Clearstream Ty Hunter comments Email.pdf

Please find attached are comments relating to the proposed rules of 64E-6.009 Florida Administrative Code.

RE: Proposed 64E-6.009, ID: 20209870, Volume 44/57

Figure 1. In-ground Nitrogen-reducing Biofilter media layer system

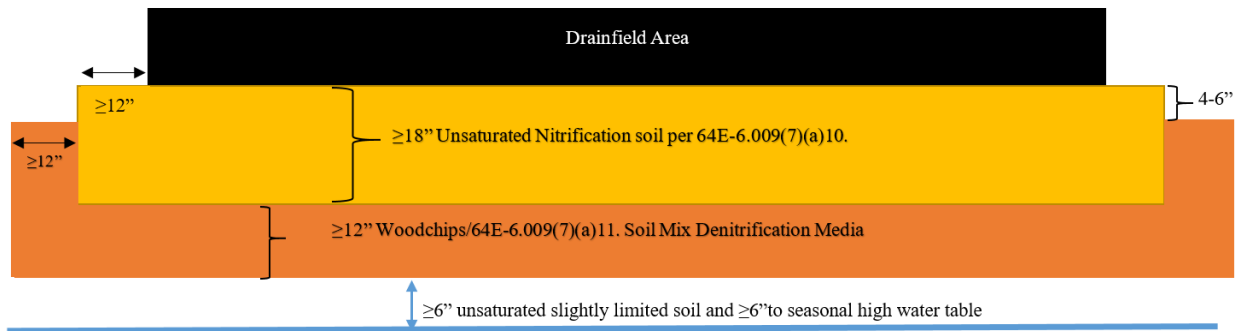
3. The bottom of the media layer shall be at least 12 inches above the wet season water table. (NOTE: change figure beneath woodchips from 6” to 12”’. Change citations to 64E-6.031(3))
